Barnhill SHD

Stage 1 Road Safety Audit

<b>Document Ref:</b>	<b>P22-091-RSA-PD-RP-001</b>
----------------------	------------------------------

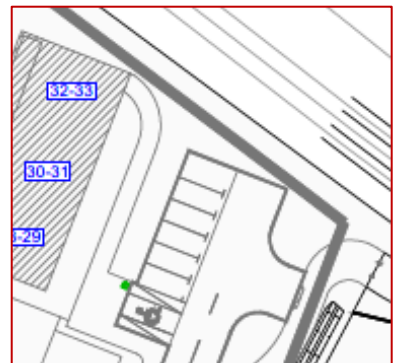
Summary: Unclear if safe vehicular access/egress from parking spaces at the end of cul-de-sac sections of internal roads can be achieved in all instances.

In a number of locations parking spaces have been indicated at the end of cul-de-sac sections of internal roads, and it is unclear from the information provided whether safe vehicular access can be achieved to/from these terminal spaces.

Should there be insufficient room for vehicles entering/exiting these parking spaces, this could result in collisions with vehicles in the adjacent parking spaces resulting in material damage.

The proposed parking spaces within the development should permit safe entry/exit, and the adjacent road layout should accommodate the swept path of the type of vehicles intended to use these parking spaces.

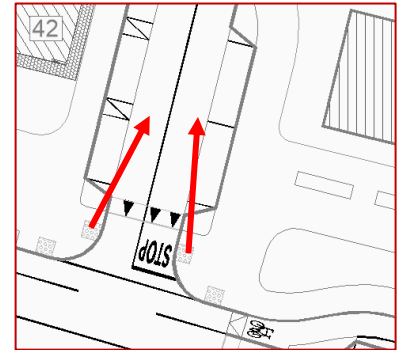
Summary: Edge protection not indicated at the edge of the ditches along the Greenway.

There are existing drainage ditches along the Barberstown Lane North, part of which is shown as being retained for use as a Greenway within the proposed development.

It is unclear if the existing ditches along Barberstown Lane North are to be modified. Should the ditches be retained in their current form, there is a risk that they would present a height-hazard for pedestrians and cyclists on the Greenway, with a risk of personal injury should a pedestrian or cyclist fall into the ditch.

Along the Greenway a review of the existing ditches should be undertaken during the next design stage, and the existing arrangement should be amended if required to remove any risk of falls from height.

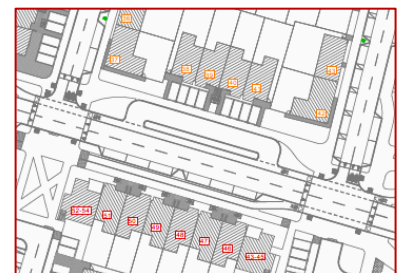
*Summary:* Visibility at “Link Road West” junction with R149

The access junction to the Link Road West Area is located at an existing side road junction. During the Site Visit it was noted that visibility for vehicles exiting from the existing junction, in both directions along the R149 and in particular to the south, is relatively poor.

It is unclear from the information provided whether it is intended to improve visibility for vehicles exiting at this location. Should the visibility for exiting drivers not be improved, this could result in unsafe exit manoeuvres leading to possible side-on collisions.

Adequate visibility should be provided for drivers exiting at this junction location.

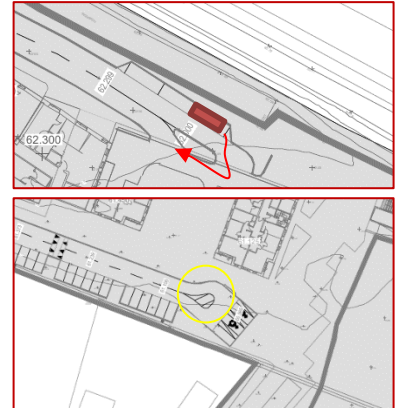
*Summary:* Approach angle to the junction may result in insufficient visibility to approaching cyclists or traffic.

It is proposed to provide a parallel access road serving Units 38 to 41 within “The Cross” area. The access road is relatively narrow, and it is unclear if this is intended to be a two-way section of carriageway, or one-way.

In addition, it may be difficult for exiting drivers to approach the junction with the Spine Road at an angle close to 90°, which may result in limited visibility towards approaching cyclists or vehicles in one, or both, directions resulting in unsafe exiting manoeuvres and possible side-swipe collisions.

The proposed road layout should be such as to permit exiting vehicles on the parallel access road to approach the junction with the Spine Road at an angle close to 90°. The permitted direction of travel should be clearly indicated to drivers.

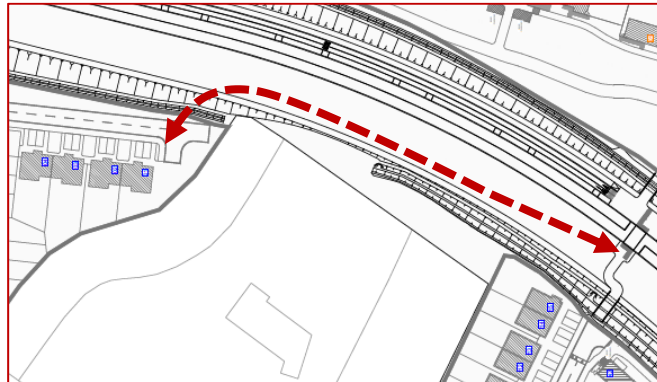
*Summary: Limited visibility within proposed undercroft parking may result in unsafe exiting manoeuvres.*

Visibility for drivers reversing out of undercroft car parking space 11 may be limited by the adjacent wall, resulting in unsafe exiting manoeuvres and possible shunt-type collisions.

Adequate inter-visibility should be provided between drivers of vehicles exiting from all of the proposed undercroft car parking spaces and approaching drivers on the aisles.

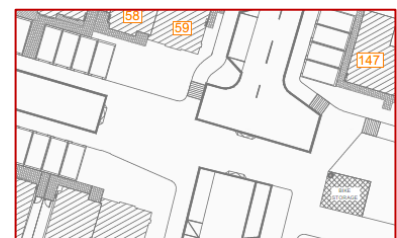
- 4.2 Bevelled Kerbs for cyclist access to/from the shared paths and the carriageways within the development have been indicated at many locations.

At this early stage in the design development it is unclear what the upstand on these kerbs is proposed to be. Should the upstand be too low there is a risk of visually-impaired pedestrians inadvertently entering the carriageway where they are at increased risk of being struck by a vehicle.

During the design development ensure an appropriate height of kerb is provided for cyclist access ensuring visually impaired are adequately warned of the carriageway hazard.
